FIVE RIVERS METROPARKS

**WESLEYAN METROPARK ADVENTURE CENTRAL
KITCHEN MODIFICATIONS AND UPGRADES PROJECT
BID NO. 20-003
Bid Addendum No. 04
March 26, 2020**

TO: ALL PLANHOLDERS

6 ROOF CURB DETAIL
SCALE: 3" = 1'-0"

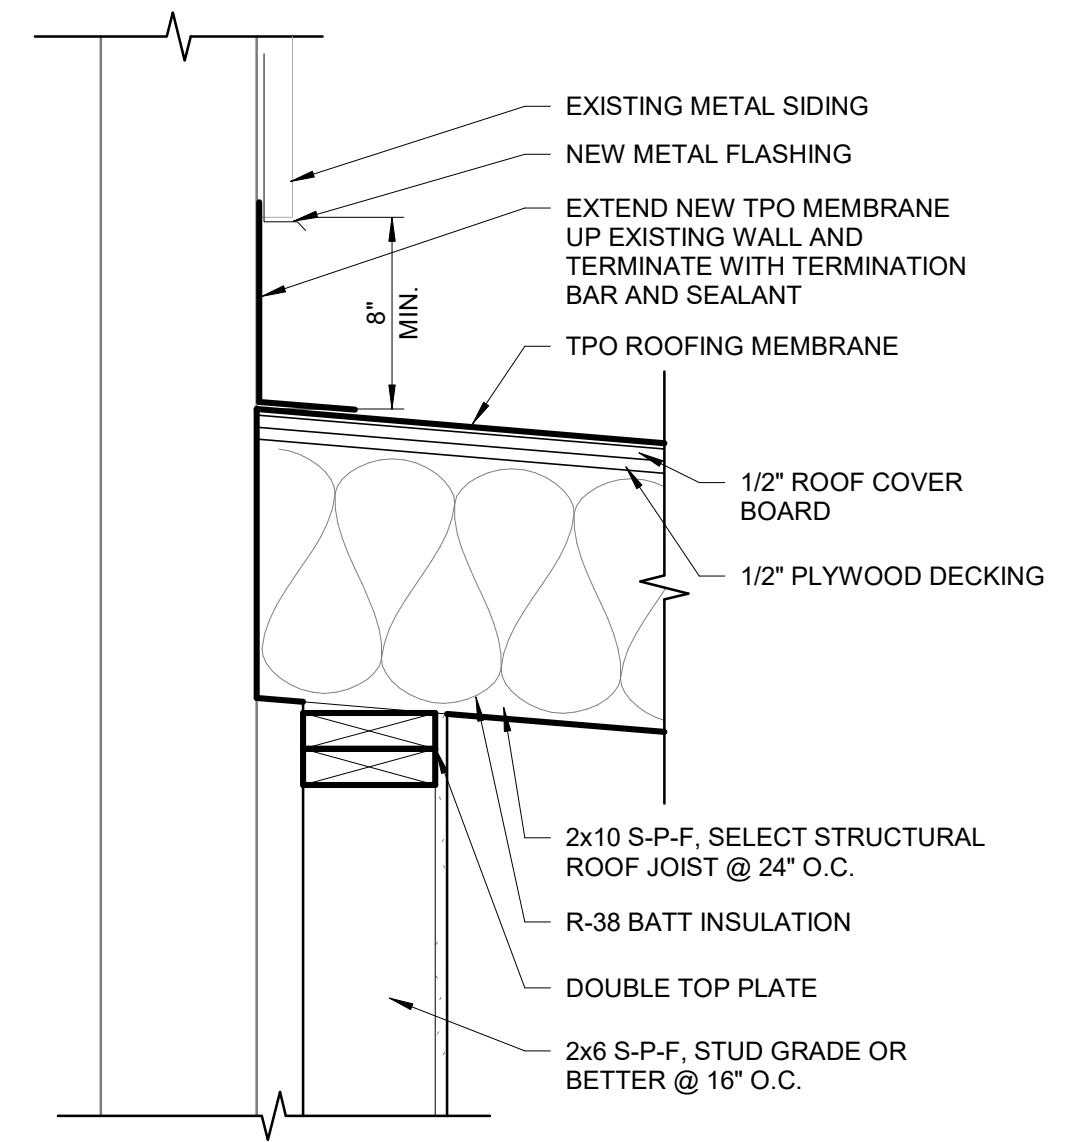
2. SHEET A-131 – REFLECTED CEILING PLAN AND ROOF PLANS – DETAIL 6 – ROOF CURB DETAIL

New detail added for roof curb. Detail reference added to Roof Plan. See revised drawing A-131, dated 3/25/20, attached to this addendum as Appendix A.

4 WALL SECTION
A-201 SCALE: 1/2" = 1'-0"

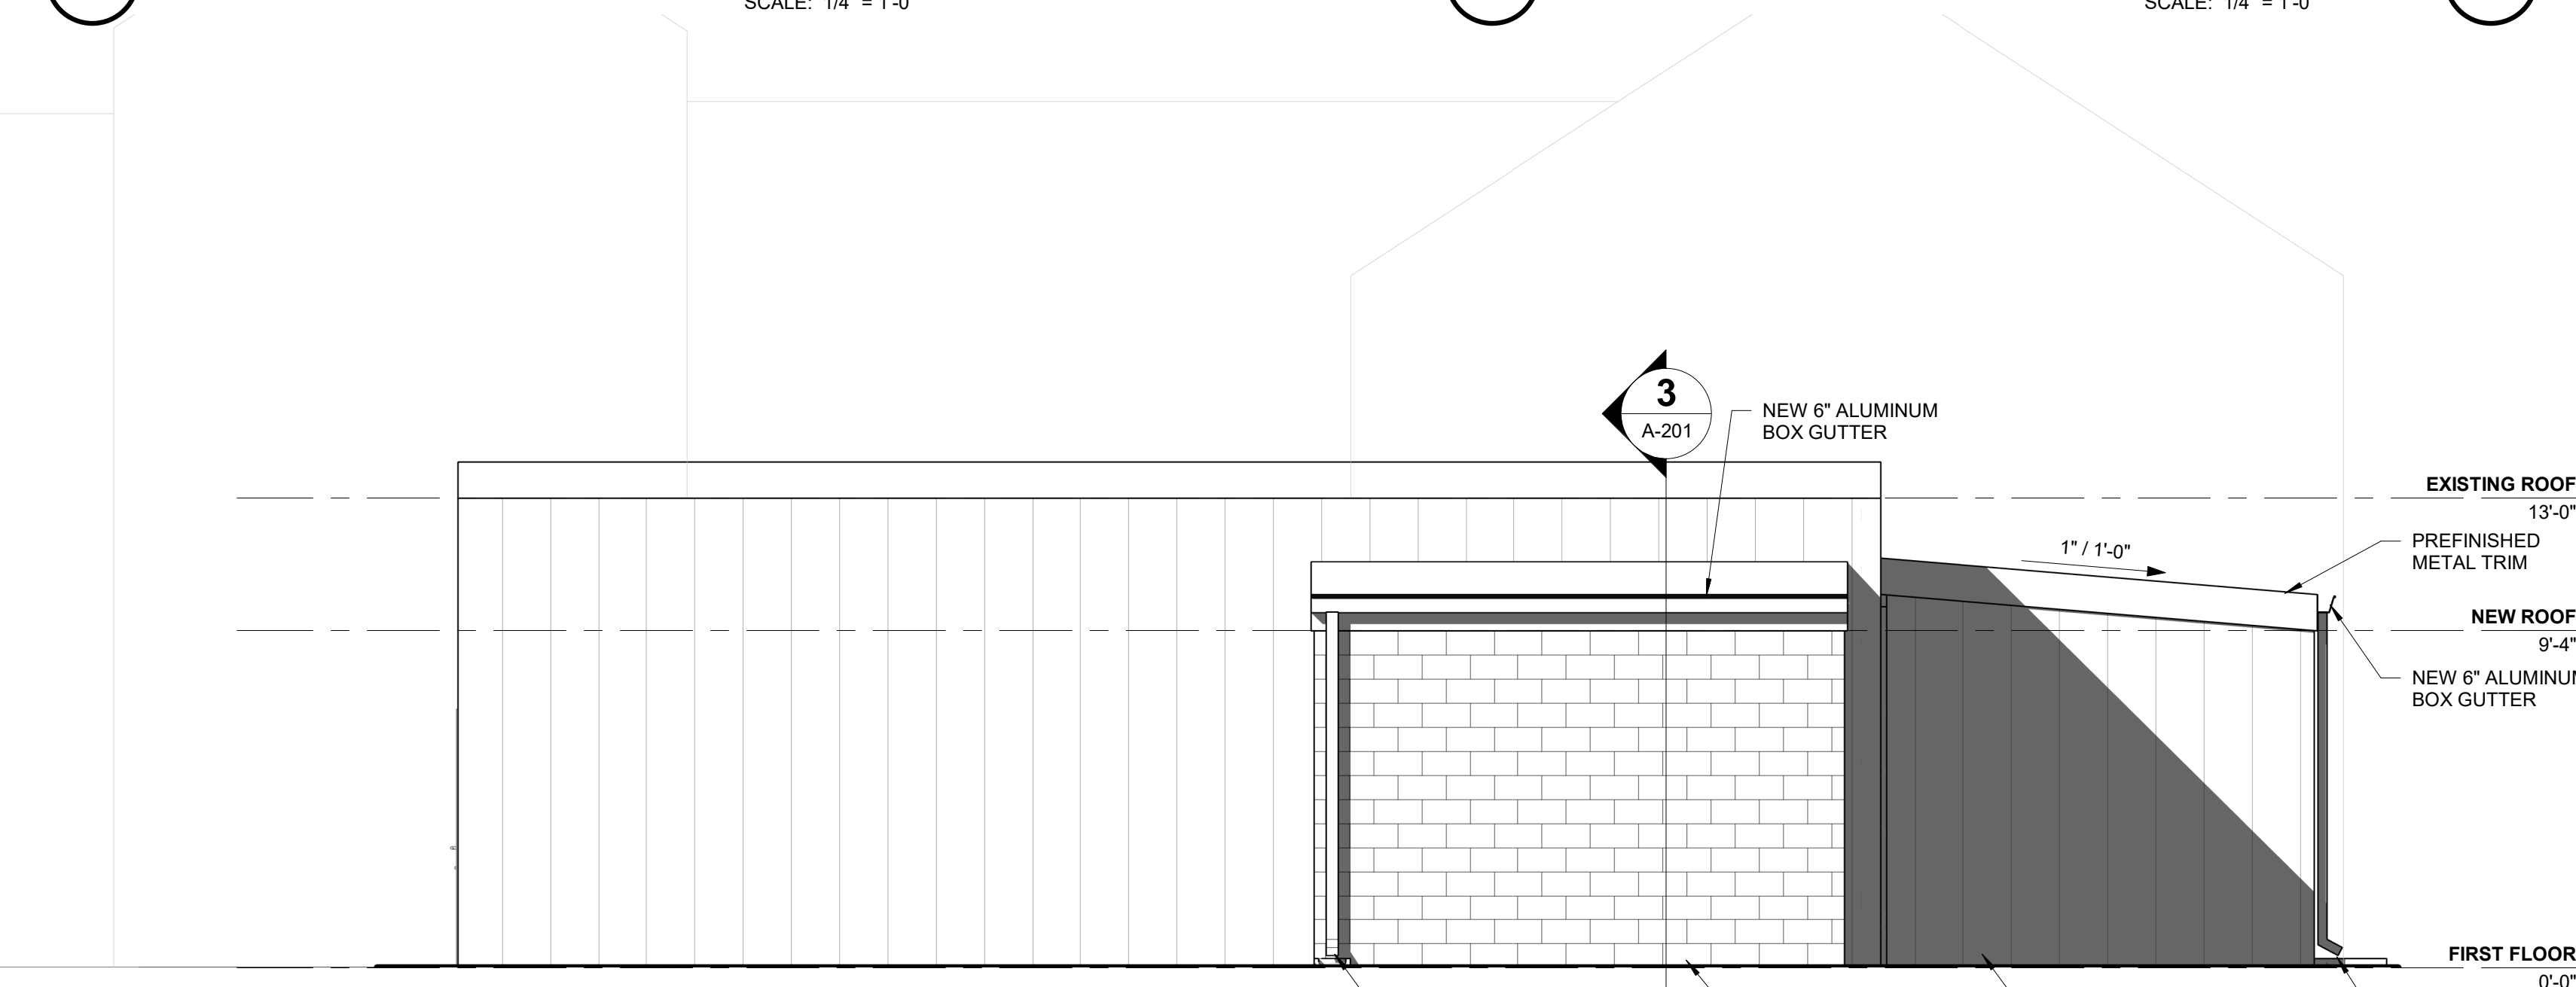
3. SHEET A-201 – BUILDING ELEVATIONS – DETAIL 4 – WALL SECTION

Added notation of building wrap. See revised drawing A-201, dated 3/25/20, attached to this addendum as Appendix B.
